**Planning Commission Agenda
Wednesday September 28, 2022 – 6:30 PM
Minturn Town Hall / Council Chambers
302 Pine St Minturn, CO**

To: Planning Commission
From: Madison Harris, Planner I
Date: September 28, 2022
Re: 962 Main Street - Changes to Approved Plans

Warner Hopkins, representative of 962 Main Street, received approval from the DRB on February 23, 2022 for a new single family house. Upon further review with the property owner, certain elements of the approved plans have been changed.

Sheet Title:
Site Plan

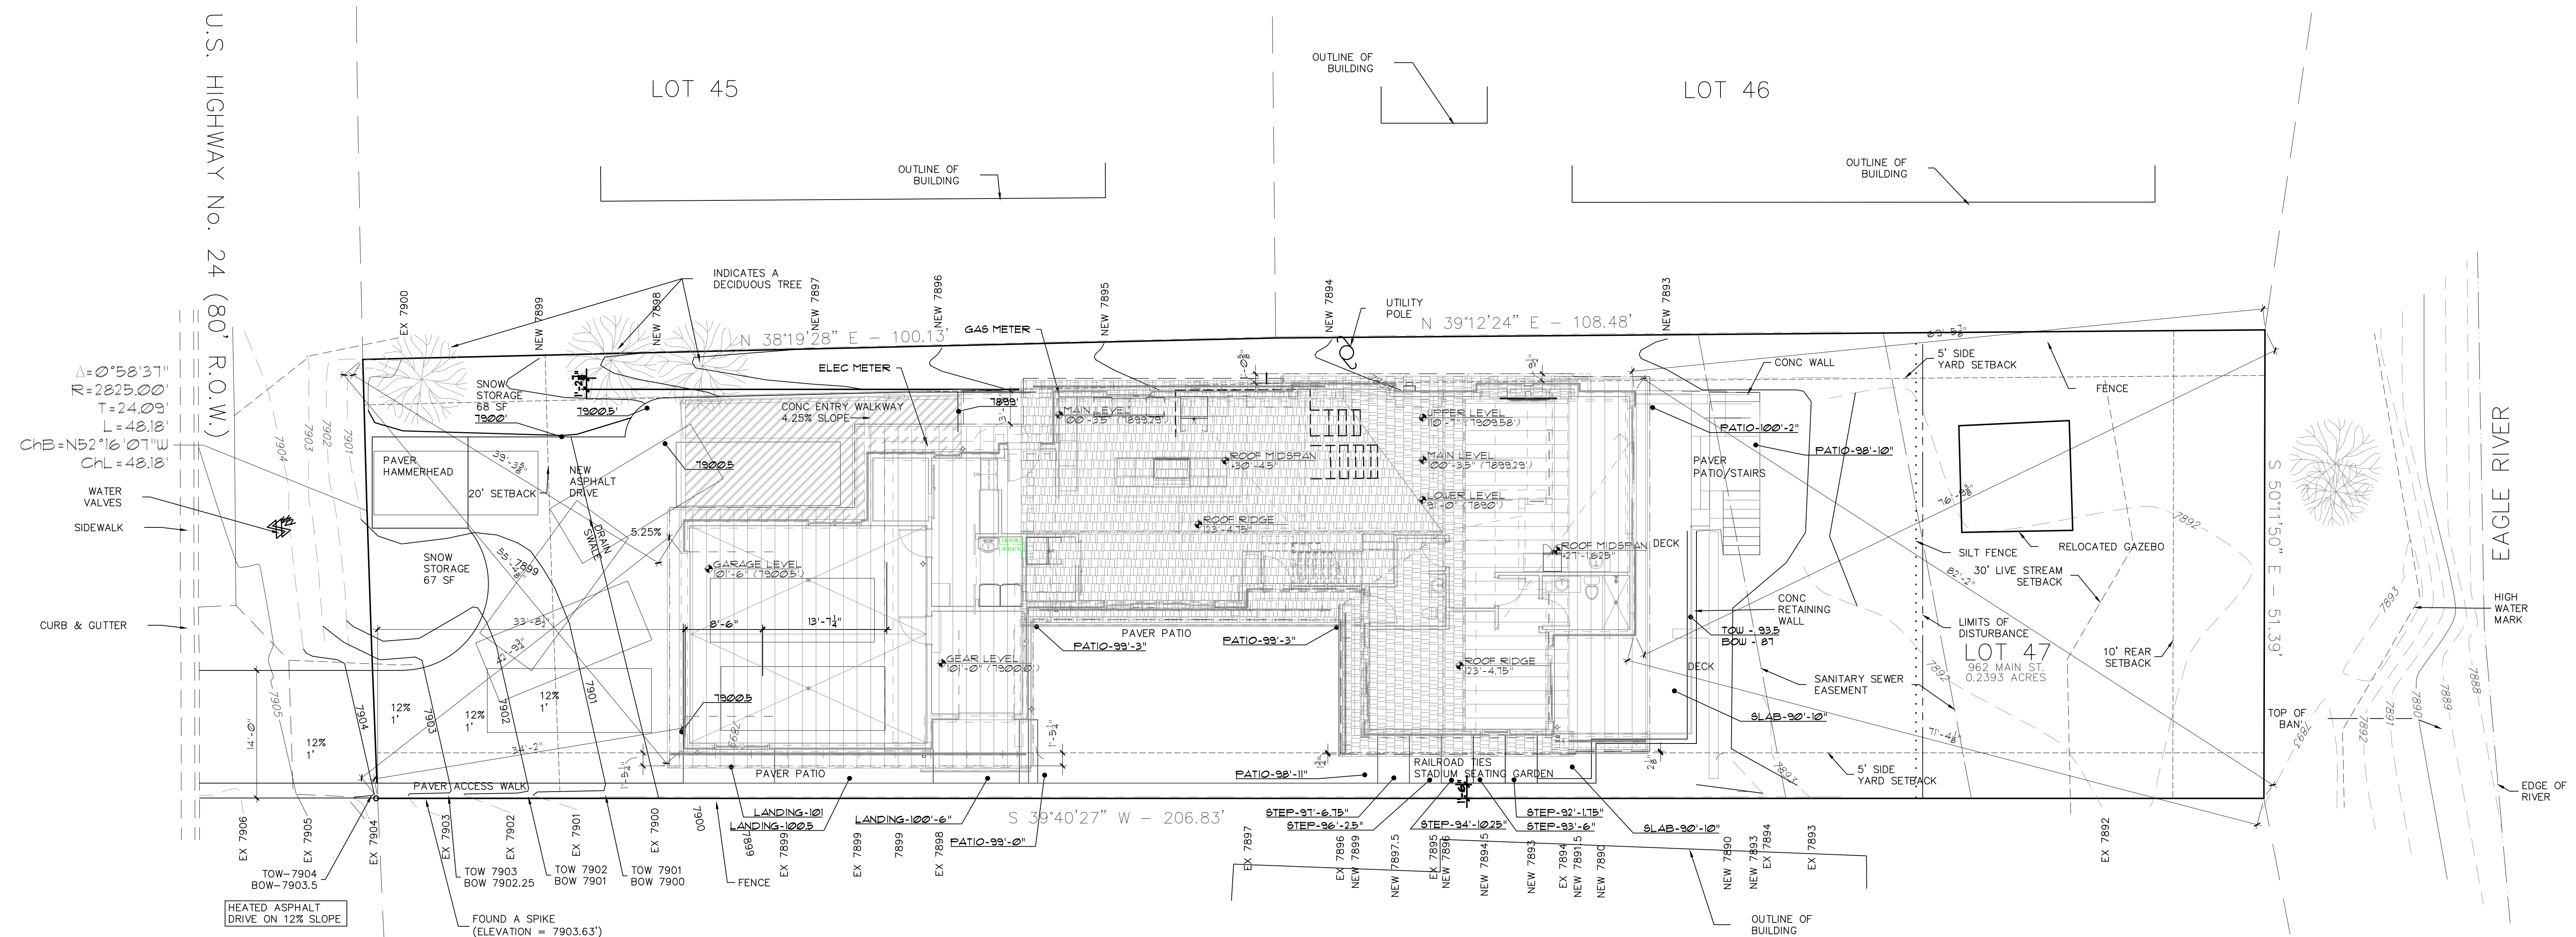
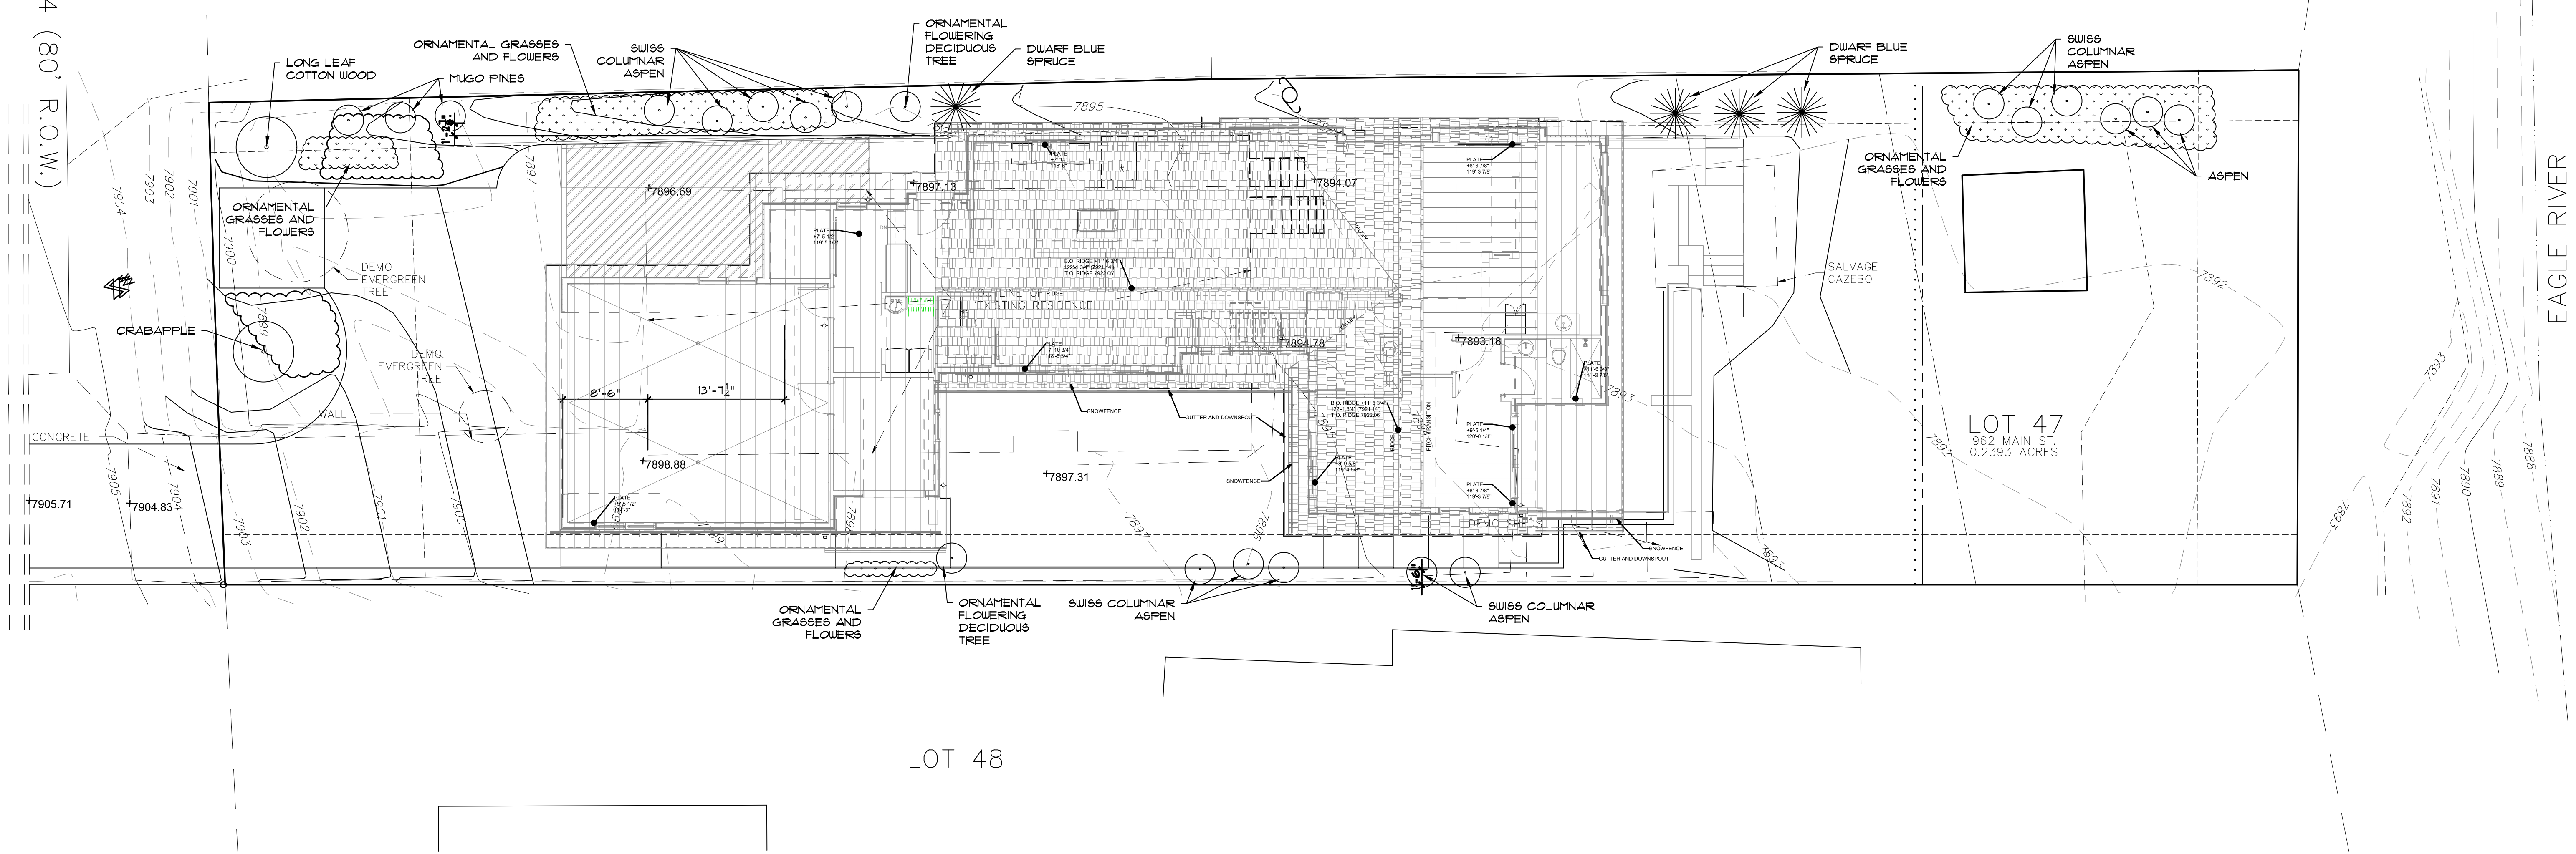
The lot coverage has changed from 3,367.4 sq. ft. to 2,755.7 sq. ft., and the impervious coverage has changed from 4,519.6 sq. ft. to 3,511.7 sq. ft. The back patio and deck have become smaller, pulling away from the rear property line. The removal of the pool also helps to account for this reduction in impervious area. The plans still show four parking spaces, two in the garage, and two in the driveway which still meets the code.

Staff believes that the proposed modifications will not change the project’s conformance with the applicable standards of Chapter 16 – *Zoning*, or Appendix ‘B’ – *Design Standards and Guidelines* of the Minturn Municipal Code.
